Released Date: 2010/02/14	Revision: A02	Model: ACE	Material Used: 76H06053-00M
Title: Repair notice for ACE auto reboot issue			Reference DOC: DOC-00088439
Revision Detail: Add date code of S/N range in condition to follow			
Category: H/W Related	Related Team: <input checked="" type="checkbox"/> WW ASP	Failure/Repair Code: If defect found (Auto reboot) : F200 vs. P002 If NFF refurbishment : NFF vs. C003	
		Effective Date: 2010/02/14

Description:
This Service Advisory aims to prevent and resolve the device auto reboot issue for **any returned ACE units**.

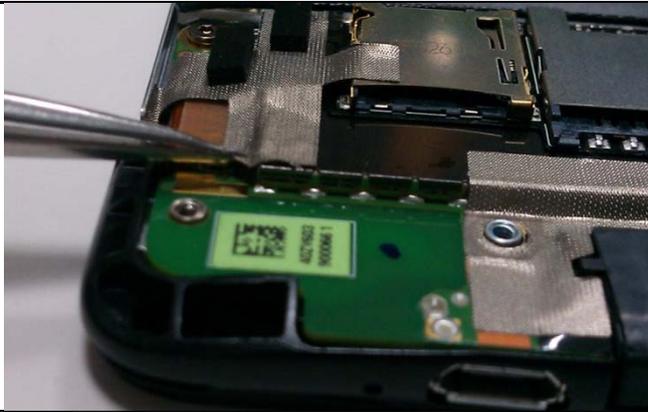
Please follow the actions to fold and stick the extra part of the conductive tape when you repair the unit.

The gasket has a risk of shorting with reset pad.

Use the tweezers to stick the extra gasket inward (adhesive against adhesive).

Inspect and make sure the gasket does not come in contact with the reset pad of the main board.
